ATTACHMENT 3 to TXX-94325

AFFECTED TECHNICAL SPECIFICATION PAGES
(NUREG-1468)

[Pages xiv, 5-6 (Inserts A and B), and
5-7 (Figure 5.6-1)]

COMANCHE PEAK - UNITS 1 AND 2
HIGH DENSITY (2/4)
xiv

FIGURE 5.6-1

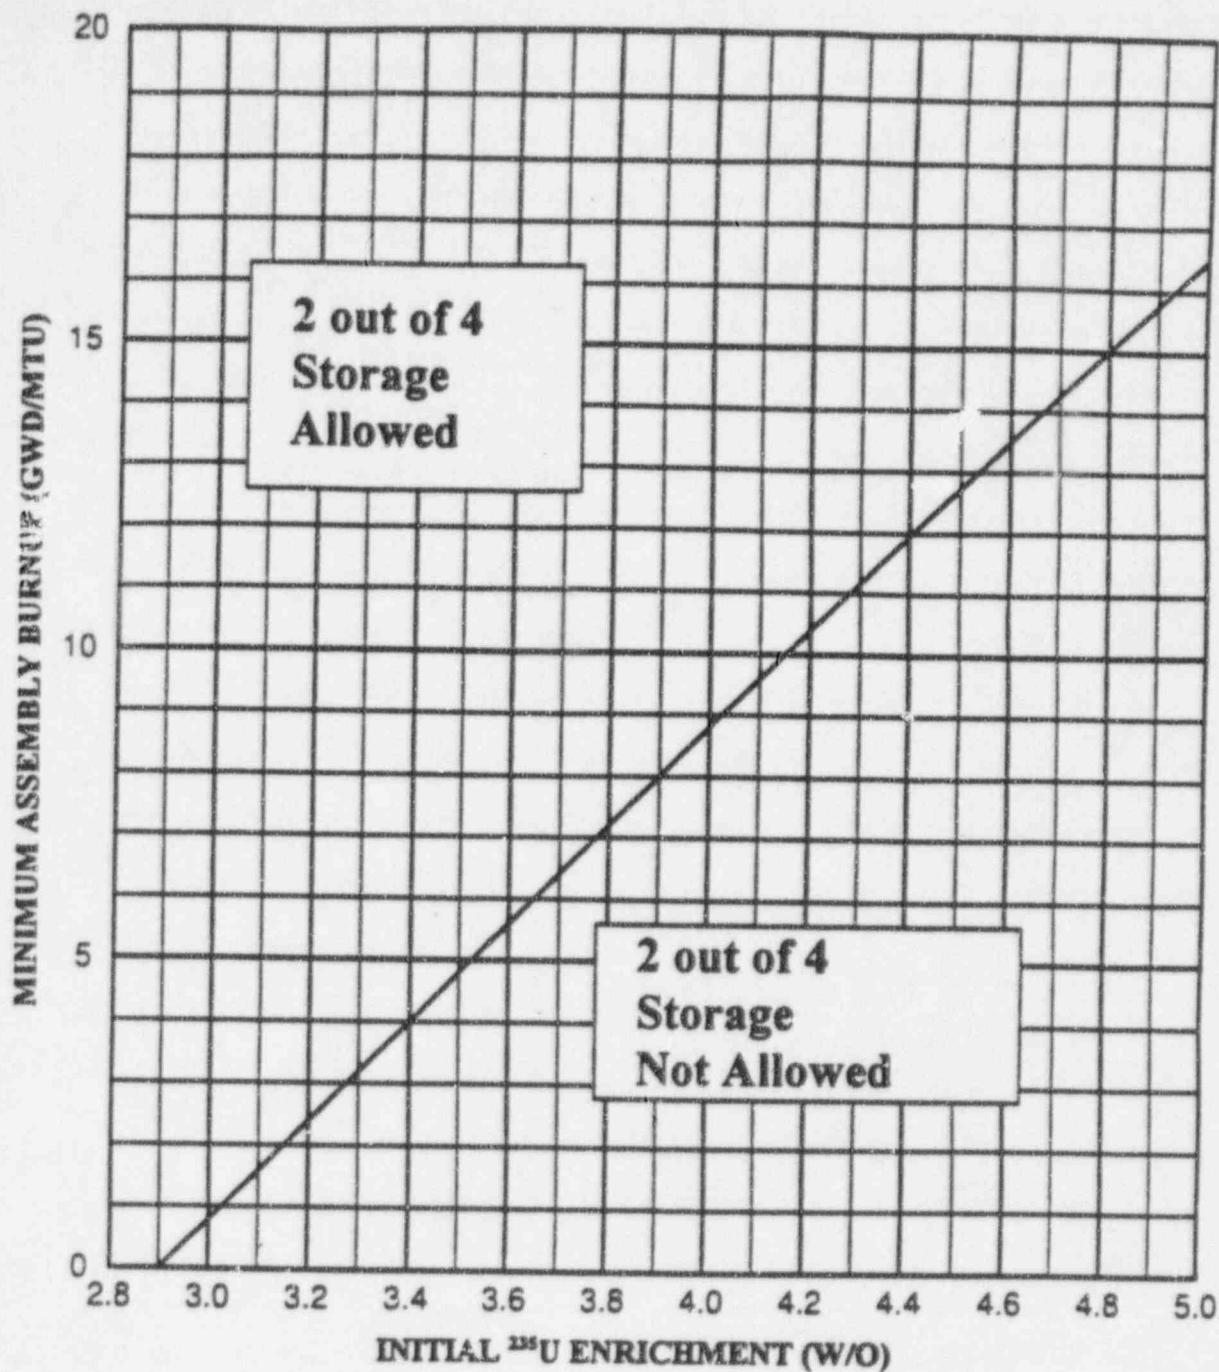
MINIMUM BURNUP VS INITIAL U-235 ENRICHMENT
FOR HIGH DENSITY (2/4) SPENT FUEL STORAGE RACKS
